# **CX32L003 Application Note 1**

## **LXT Failure Issue and Workaround Solution**

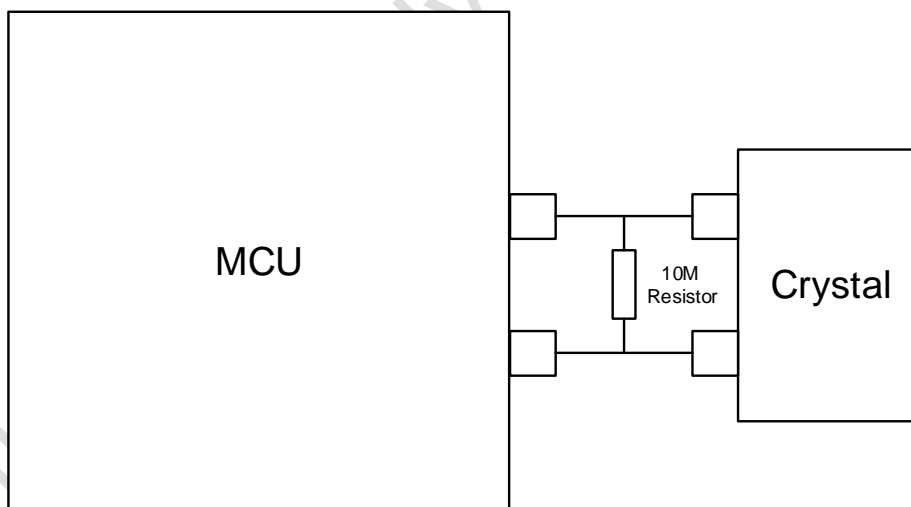
LXT can not start up normally at 85 degree temperature and 2.6 / 3.3 Voltage. The failure rate is 100% so that customer must follow the workaround solution if LXT has to be used.

The workaound solution for this issue is to connect a 10MΩ resistor between two ends of the external crystal.
